<b>Docket Number:</b>	22-BSTD-01
<b>Project Title:</b>	2025 Energy Code Pre-Rulemaking
<b>TN #:</b>	244284
<b>Document Title:</b>	NRDC et al Comments on July 18 2022 Energy Code Accounting Workshop
<b>Description:</b>	N/A
<b>Filer:</b>	System
<b>Organization:</b>	NRDC
<b>Submitter Role:</b>	Public
<b>Submission Date:</b>	8/1/2022 2:06:35 PM
<b>Docketed Date:</b>	8/1/2022

**NRDC et al Comments on July 18 2022 Energy Code Accounting Workshop**

Figure 1: CEC’s Proposed Demand Scenario for the 2025 Building Energy Code

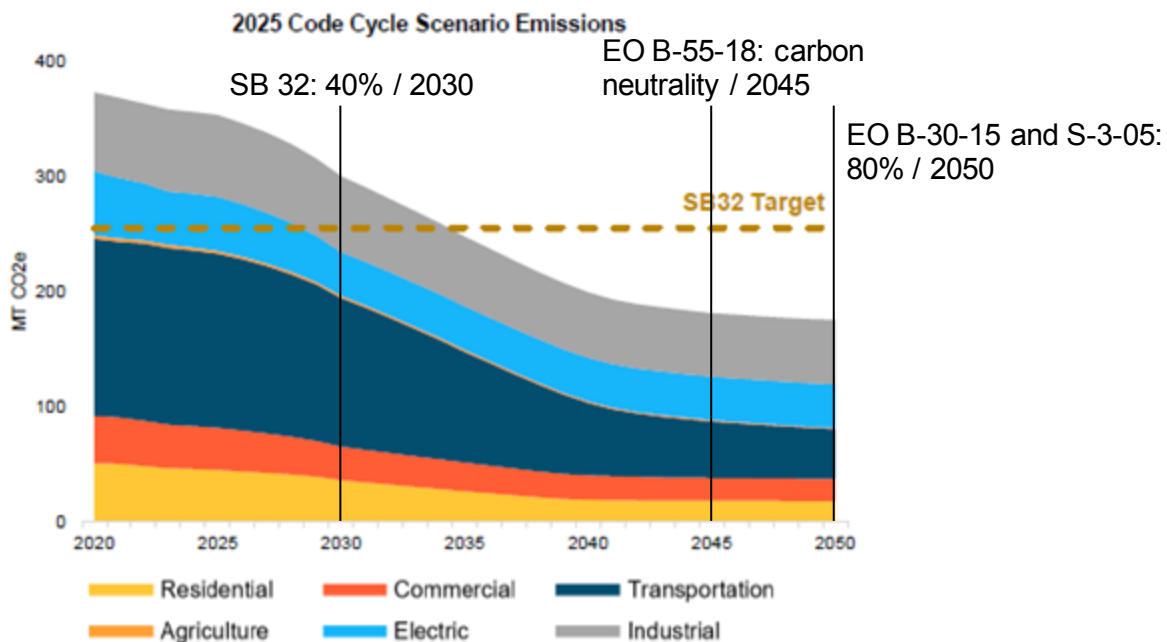
We appreciate the work of the CEC staff and their consultants to develop the information presented. However, we are concerned that the demand scenario considered for the 2025 standards are non-compliant with state decarbonization requirements. The proposed demand scenario fails to meet key state climate goals, including those set by Governor Newsom on 7/22/2022, and those mandated by SB 32 and Executive Orders B-55-18, B-30-15, and S-3-05, as shown in Figure 1 below.

As described above, the proposed scenario does not meet California’s requirement to “ensure that statewide greenhouse gas emissions are reduced to at least 40 percent below” 1990 levels by 2030 or its objective to achieve carbon neutrality by no later than 2045.<sup>1</sup> The CEC’s presentation stated that the “selected scenario should represent a realistic load forecast based on on-the-books existing policies and expected future policies.” California may not have all the policies necessary to meet those goals in place yet, but policies are never all in place at the beginning of an energy transition, they are developed and funded as the transition progresses. This was the case with solar, EVs, batteries, and will be the case with building decarbonization.

We urge the CEC to reconsider the proposed demand scenario and select a scenario that reflects the state's climate commitments.
